Contract # : **04-0120E4**Cty **SF** Rte **80** PM **13.4, 13.8**File # **13.25 B****QUALITY ASSURANCE - NONCONFORMANCE REPORT****Location:** Vancouver, WA**Date:** 6-14-06**Prime Contractor:** Kiewit, FCI, Manson, (KFM) Joint Venture**NCR #** 097**Submitting Contractor:** Oregon Iron Works**Type of problem:****Welding**  **Concrete**  **Other** **Welding:**  **Curing:**  **Procedural:**  **Bridge No.#** 34-0006**Joint fit-up:**  **Coating:**  **Other:**  **Component:** # E2**Procedural:**  **Procedural:** **Description of Non-Conformance:** QA observed that KFM and OIW quality control allowed welding of partial penetration joint at south pod girder 121-2 to girder 181-4 web where fit-up gaps of 7 to 12+ mm substantially exceeds the 3 mm as allowed by AWS D1.5 figure 2.5, section 3.3.2, and WPS #3245.**Applicable reference:** AWS D1.5 2002**Who discovered the problem:** Caltrans Quality Assurance Inspectors**Name of individual from Contractor notified:** OIW QC managers Russell Lynch and Nate Lindell**Time and method of notification:** 6-14-06 at 1645 hours**Name of Caltrans Engineer notified:** Mark Vilcheck, Structure Representative**Time and method of notification:** June 15, 20

3279 FCM

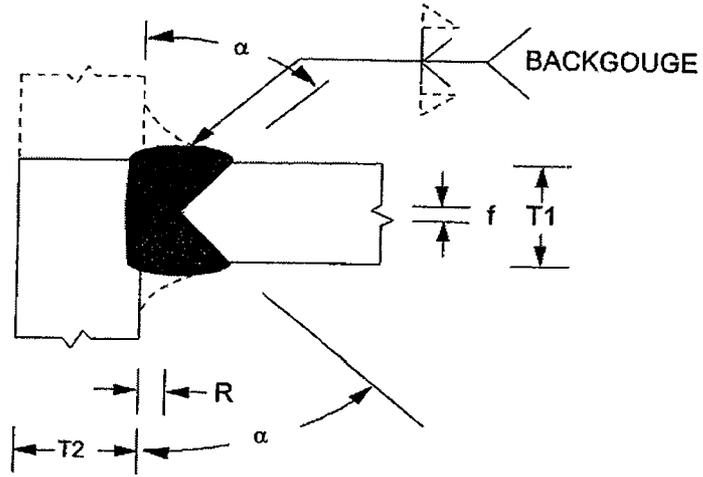
**Contractor's proposal to correct the problem:** Change joint designation from a partial penetration joint to a complete penetration joint. Excessive root opening to be corrected by flux core arc weld buttering to conform to joint configuration for complete joint penetration per AWS D1.5-2002, figure 2.4, TC-U5-F, and WPS 3279.
